V2500-A5/D5 SERIES PROPULSION SYSTEM SERVICE BULLETIN

This document transmits the Initial Issue of Service Bulletin V2500-ENG-72-0569

INFORMATION – ENGINE – PROVIDE A NEW NO. 3 BEARING1. Planning InformationA. Effectivity

Engine - No. 3 Bearing
Figure 1

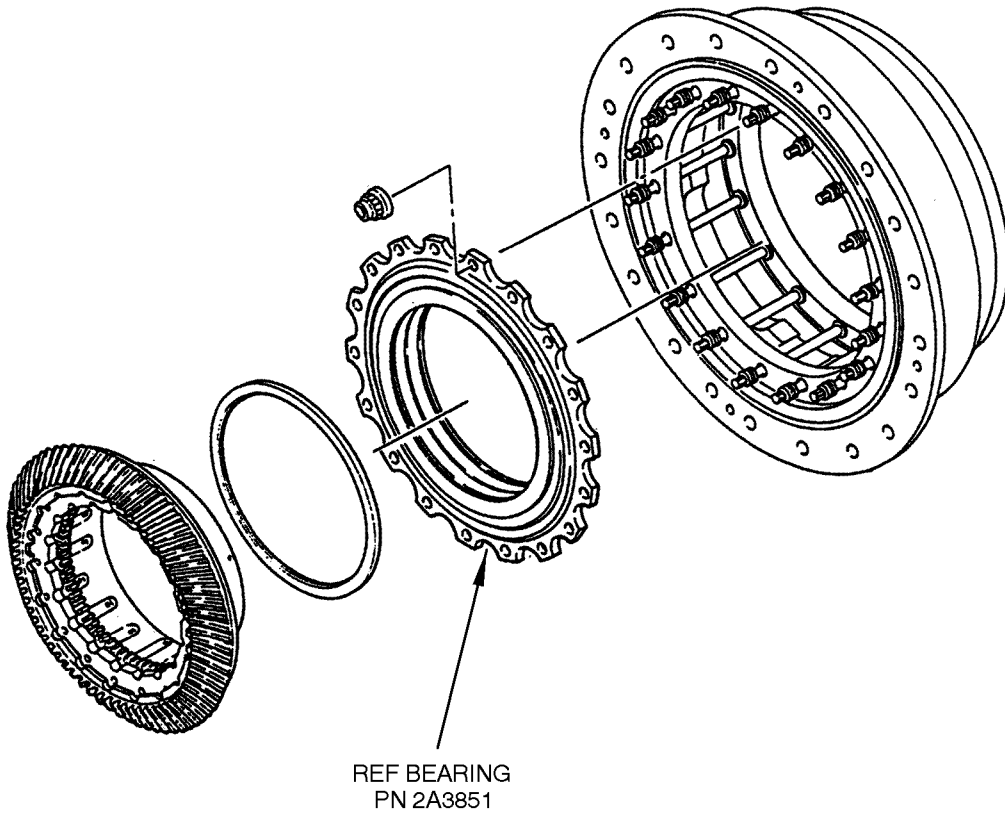
Introduce new No. 3 bearing, P/N 2A3851, as an alternate bearing for current MRC No. 3 bearing P/N 2A1170 and FAG No.3 bearing P/N 2A4022. This bearing material change provides product improvement to decrease post-spall (distress) progression rate and improve resistance to crack propagation of outer ring in the event of distress.

Provide a new No. 3 bearing as an alternate to P/N 2A1170 and P/N 2A4022.

REF BEARING
PN 2A3851

P/N 2A1170 bearings and P/N 2A3851 bearings are fully interchangeable. For Spares, P/N 2A4022 bearings are fully interchangeable with P/N 2A1170 bearings and P/N 2A3851 bearings.
